CONTRACT CHANGE ORDER No. 170
SHEET ___ OF ___

ROADWAY LEVEL EASTBOUND LIGHTING AND ELECTRICAL SYSTEMS

ROADWAY LIGHTING POLE LOCATION PLAN-SHEET 56
SKYWAY STRUCTURES
NO SCALE

E-75

EE-56

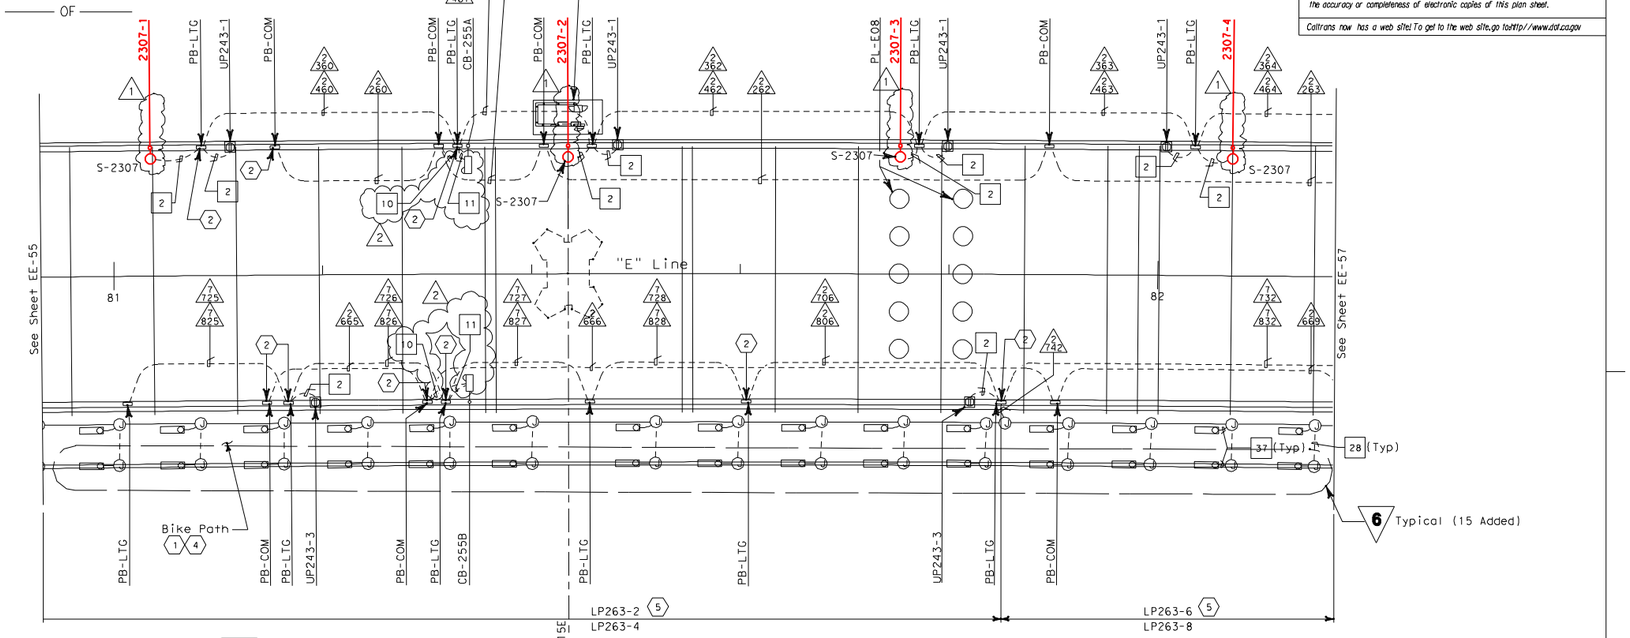
MARK	DATE	DESCRIPTIONS	REV	CK	
2	1/20/06	Delete CB-255A & CB-255B. Coil 5 m of call box signal and power cable in adjacent PB-COM and PB-LTG pull boxes.	JE	EJL	CCO No. 170
1	3/2/05	Delete Roadway light poles and fixtures. Coil 10m, 3#10 conductors in the pull box adjacent to light pole locations.	RS	PB	CCO No. 123
